2017 REVISION TABLE

(To the 2016 Electric Line Extension and Service Standards)

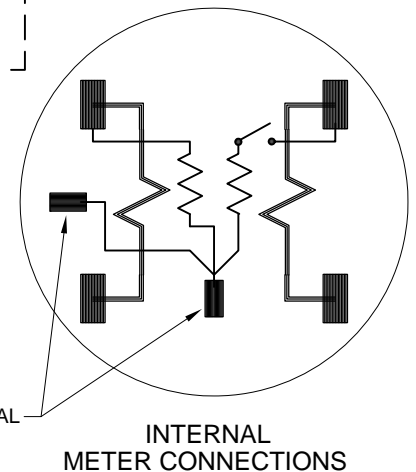
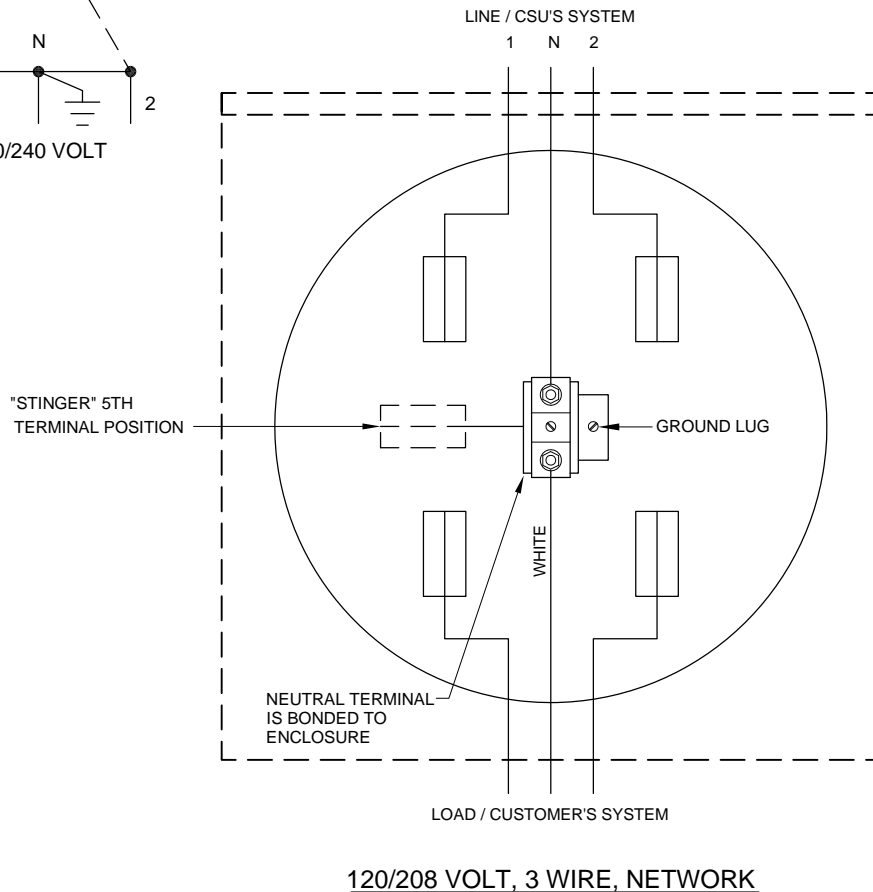
Deleted part of note 5: "For overhead services, meter sockets are furnished with a hub sized as needed, available hub sizes are 1-1/4", 1-1/2", 2", 2-1/2" and 3"."

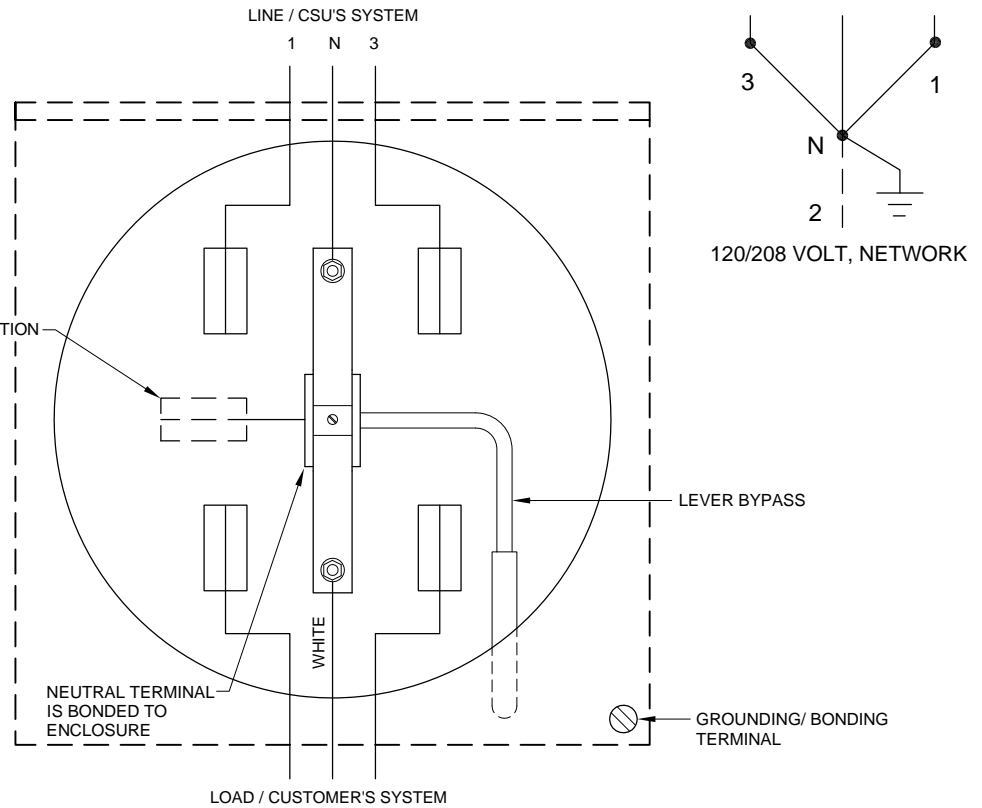
Deleted Note 6: "For overhead services, meter sockets are furnished with a hub sized as needed, available hub sizes are 1-1/4", 1-1/2", 2" and 2-1/2"."

3 PHASE, 4 WIRE-WYE, 120/208 & 277/480 VOLT

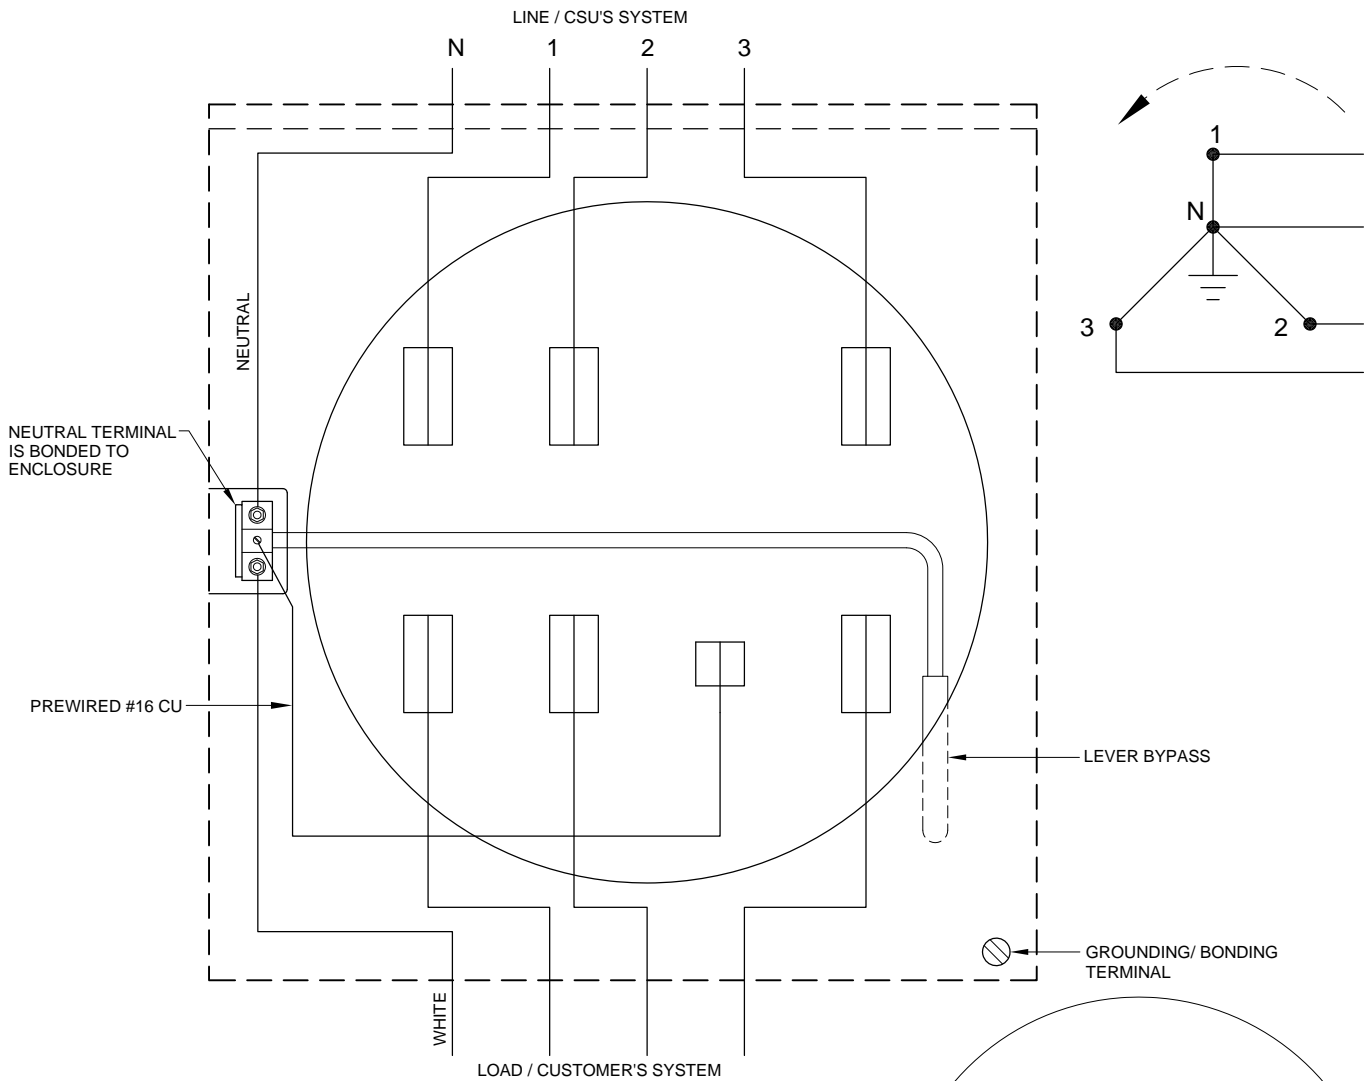
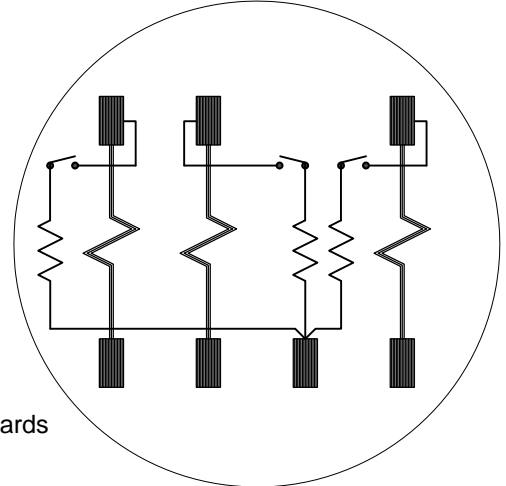
Deleted Note 6: "For overhead services, meter sockets are furnished with a hub sized as needed, available hub sizes are 1-1/4", 1-1/2", 2" and 2-1/2"."

3 PHASE, 4 WIRE-DELTA, 120/240 VOLT

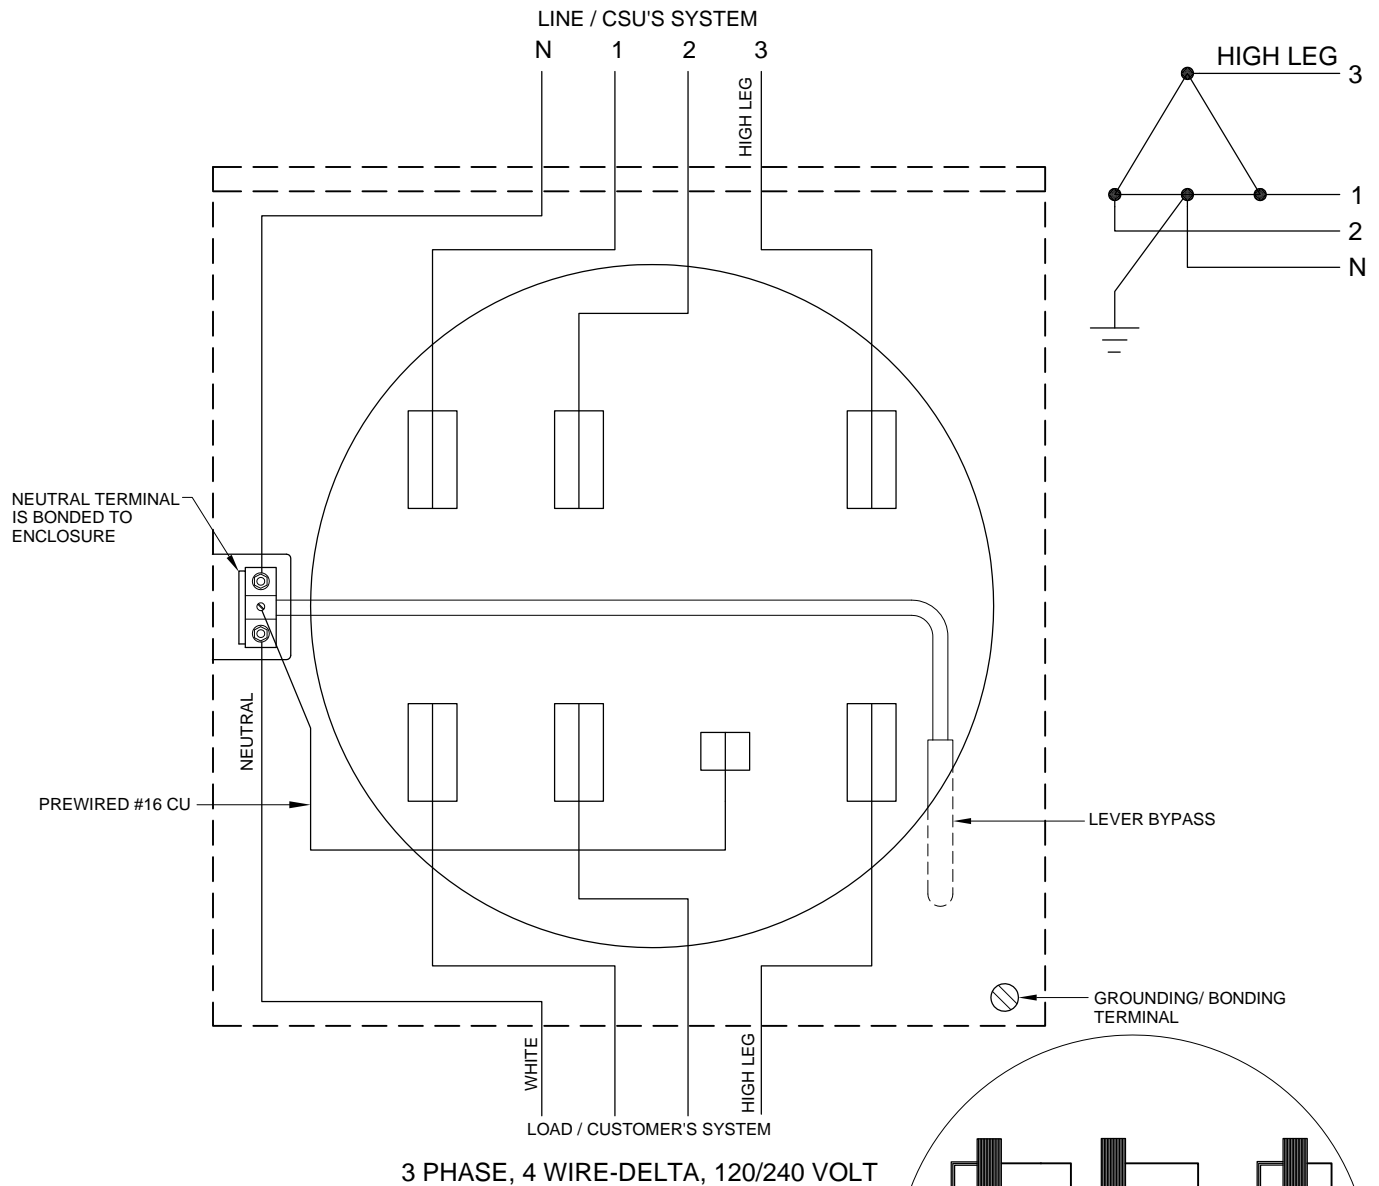
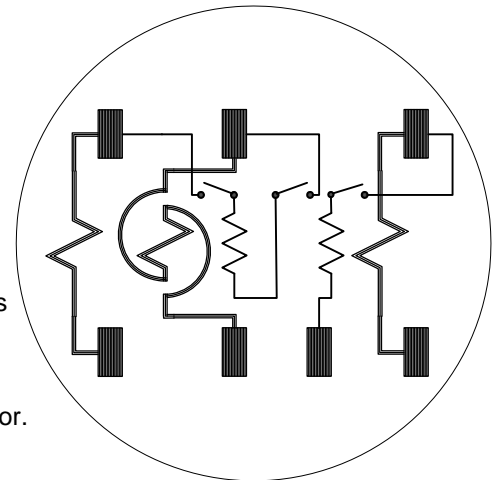
Deleted Note 5: "For overhead services, meter sockets are furnished with a hub sized as needed, available hub sizes are 1-1/4", 1-1/2", 2", and 2-1/2"."

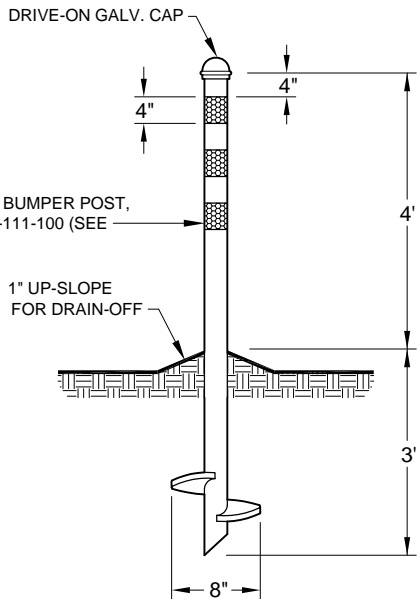
Deleted Note 5: "For overhead services, meter sockets are furnished with a hub sized as needed, available hub sizes are 1-1/4", 1-1/2", 2", and 2-1/2"."
